Mount Errington - 1 Rosemead Road, Hornsby SSD-10444

We object to the above development on the following grounds -

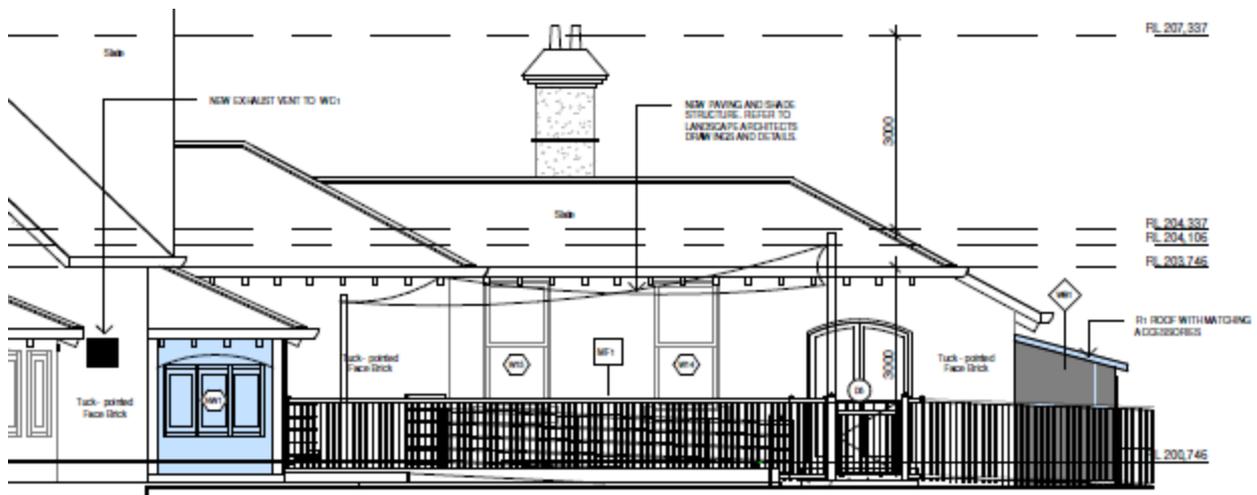
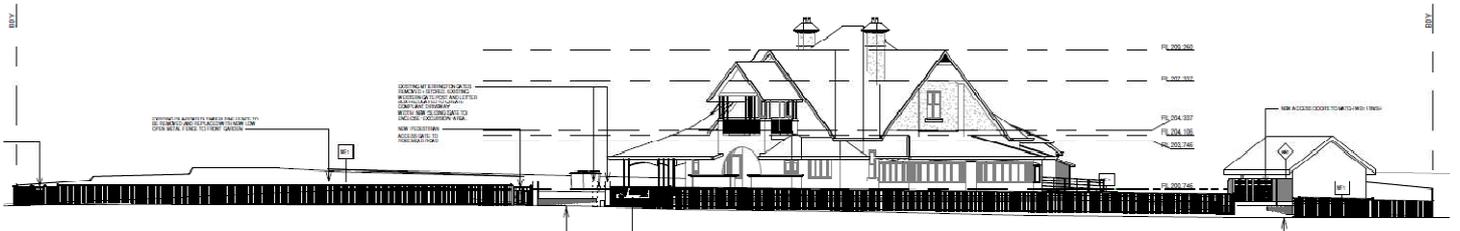
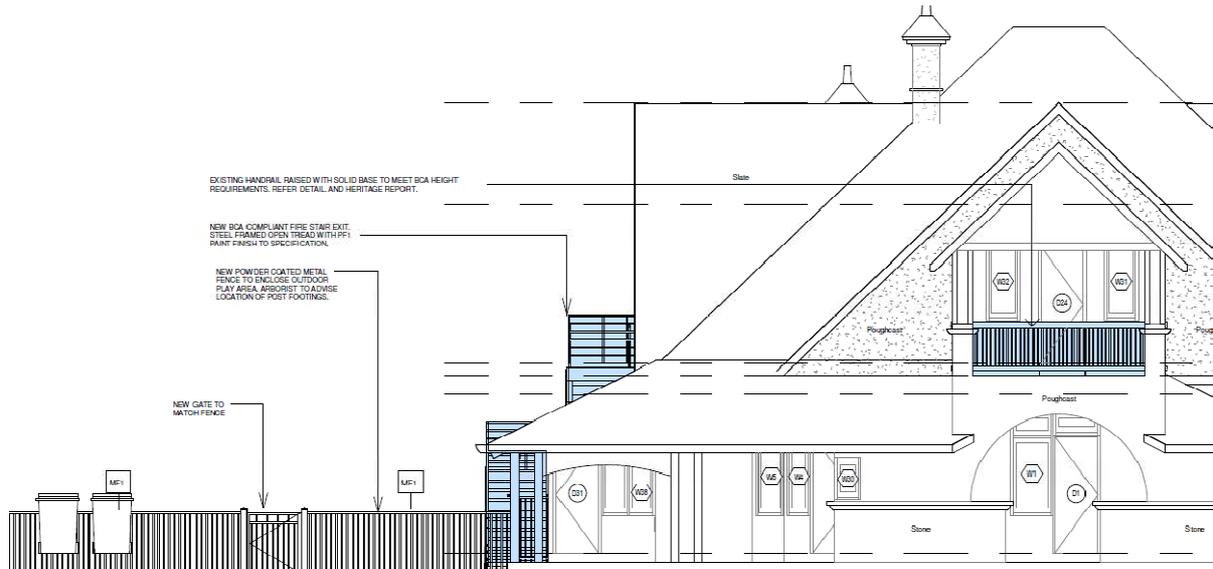
- The new black tubular steel front fence and the fence extending from side of building to boundary to enclose the play area detracts from the heritage values of the residence and does not complement the heritage property at all. It would be visible from almost every sightline both external to and within the property. What are they thinking? We think this has the heritage sensitivity of a block of concrete. Even the magnificent facade gets this ugly tubular fence as a visual extension.

Not content with that, the whole front of the property would be defaced with this incompatible, incongruous, cheap and nasty modern tubular fence, so that every person that passes this magnificent property would have to view it through a cheap, ugly black eyesore. It is not consistent with the architectural style of fencing used during the Arts and Crafts period and should be rejected outright. **Fencing that is consistent with the architectural style of the house must be used.**

- The Hornsby Shire Council Development Control Plan (DCP), Section 9 Heritage, Clause 9.2.4 Fences and Gates, Desired Outcomes, looks to "New fencing that complements the heritage significance and architectural style of the heritage item". Well they missed that by an architectural mile. **Either a picket fence or a low paling fence must be installed.**

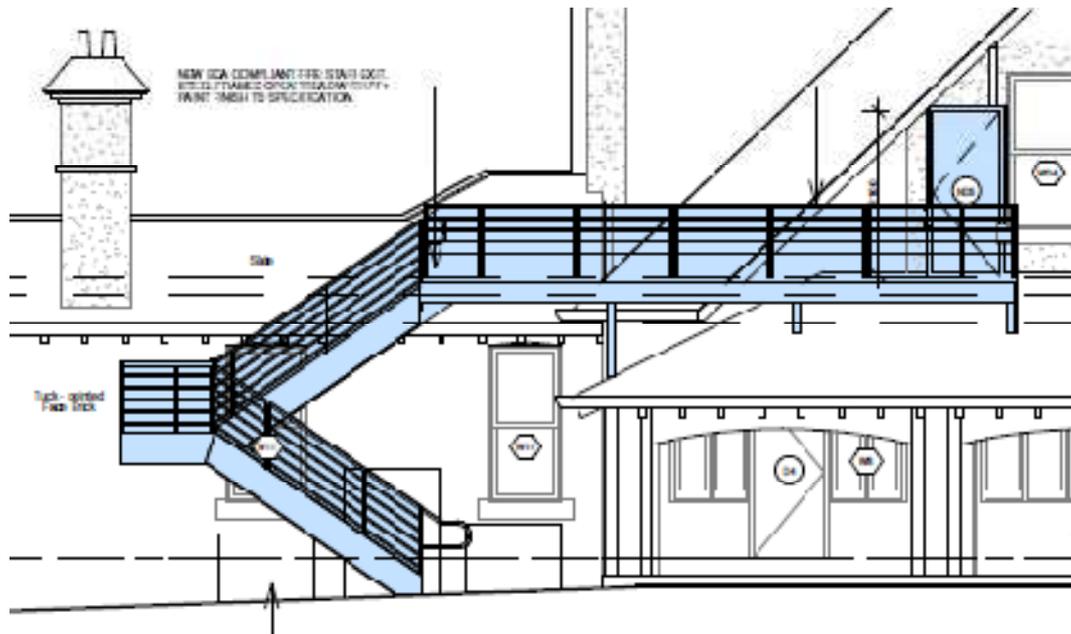
- The black fire escape attached to the building detracts from the heritage values of the residence and does not complement the heritage property at all. **Just because it's black doesn't mean it disappears. It is intrusive and detracts from the architectural lines of the house** from every angle. It is not in any way hidden. It is visible from the street view and is overbearing in relation to the house. **If that is the best that can be offered, then this DA should be refused as the proposed works are incompatible with the heritage values of the property.** It's quite simply an eyesore. Dreadful.

- **The proposed tacked on store room does not complement the heritage building in any way.** The materials used, including a charcoal tin roof, will be an eyesore that would no doubt be torn down by any future owner as being totally incompatible with the heritage values of the building. It is a square block with a flat roof that looks more like a tin shed than something that could be attached to a heritage building.

It should either be designed so that it complements the architecture of the building or put the shed in a corner of the property where it can't be seen. We think it's appalling that anyone could propose such a monstrosity of an attachment to a beautiful heritage mansion such as this. Shameful.

WORKS TO THE HERITAGE BUILDING ITSELF

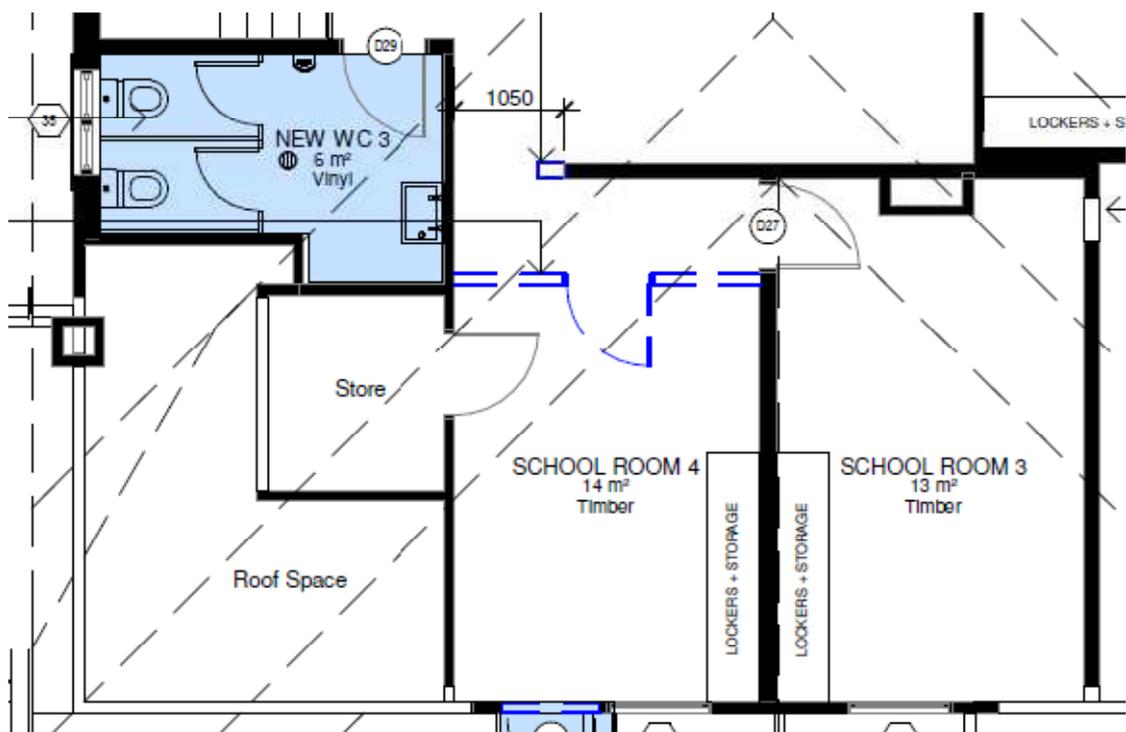
- **We think it is unacceptable to remove internal walls to reconfigure the space** (diagram below). The upstairs layout would have always had a hallway. It would never have been laid out so that one had to walk through one bedroom to get to another. It also seems poor design for a school for the students to have to walk through and disturb one class to get into or out of their classroom. **The small amount of extra space gained does not justify the removal of internal walls.**
